Access Compliance Report

Public Rights-of-Way

(Curb Ramps)

Intersection ID: N/A	Main Street: BALTUSROL_LN	Cross Street: N/A	Location: E
ADA ID: 8EC7ABCB1594	Ramp Type: Perpendicular	Initial Pass/Fail: Fail	Overall Compliance: No
		Severity Score: 10

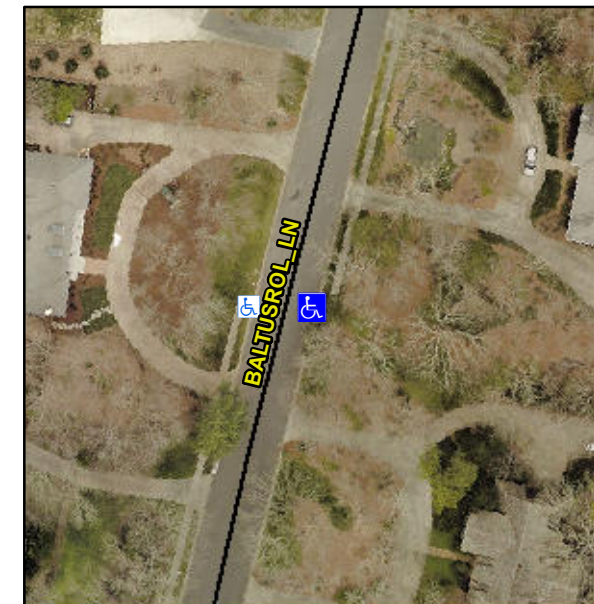
R304.5.1, R304.5.3

Compliance	Description	Data	Compliance	Description	Data
N/A	Ramp Length (in)	50.0	Yes	Ramp Slope (%)	6.7
No	Ramp Width (in)	46.0	No	Ramp XSlope (%)	4.7
N/A	Flare Type LT	N/A	N/A	Flare Type RT	N/A
N/A	Flare Slope LT (%)	N/A	N/A	Flare Slope RT (%)	N/A
N/A	Flare Traversable LT?	No	N/A	Flare Traversable RT?	No
N/A	Landing Length (in)	N/A	N/A	DWS Provided?	N/A
N/A	Landing Width (in)	N/A	N/A	DWS Contrast?	N/A
N/A	Landing Slope (%)	N/A	N/A	DWS Length (in)	N/A
N/A	Landing X Slope (%)	N/A	N/A	DWS Full Width?	N/A
N/A	Landing Curb? (Y/N)	N/A	N/A	DWS Offset (in)	N/A
N/A	Shared Landing?	N/A			
N/A	Gutter Ponding?	N/A	N/A	Gutter Slope (%)	N/A
N/A	Gutter Lip Ht (in)	N/A	N/A	Gutter X Slope (%)	N/A
N/A	Painted X Walk1?	No	N/A	Painted X Walk2?	N/A
	X Walk 1 Direction	To W		X Walk 2 Direction	N/A
N/A	X Walk 1 Width (in)	N/A	N/A	X Walk 2 Width (in)	N/A
	X Walk 1 Slope (%)	5.4		X Walk 2 Slope (%)	N/A
	X Walk 1 X Slope (%)	4.6		X Walk 2 X Slope (%)	N/A

Remove & Replace Entire Ramp.
